Junction Box FAQ 13-0006

Clarification needed

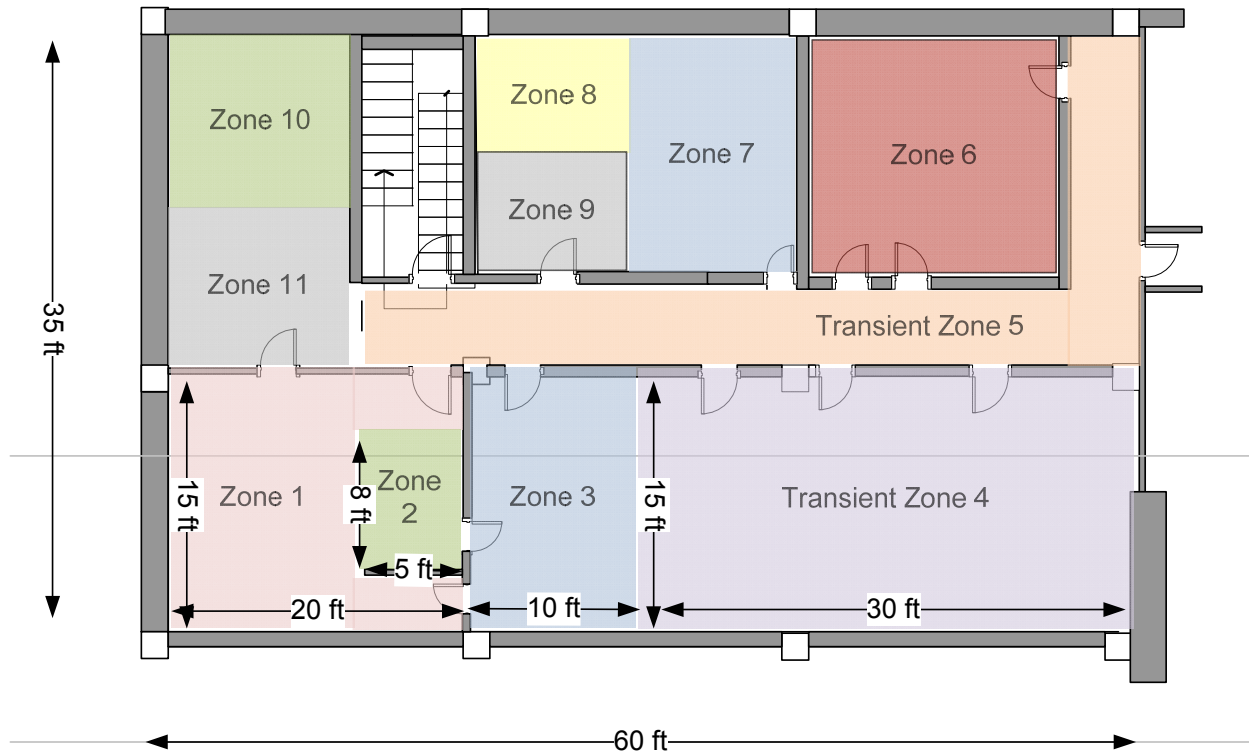
The below file was created using Visio if alterations/clarifications need to be made. An example depiction for this case would be helpful.

Questions-

1. How will the targets be identified in this method, what cables/conduits in the corresponding transient fire zones are mapped to the postulated junction box?
2. Is this new method simply adding the junction box fire frequency (apportioned on fire area) to the targets sets that are damaged within the zone of influence of the modeled transient fire for each case
3. The note was added that “even if a transient fire can be screened based on zone of influence considerations, junction box fires within that portion of the fire zone would still need to be considered.” In this case how will the targets be identified without knowing exactly what cables are included in the junction box.
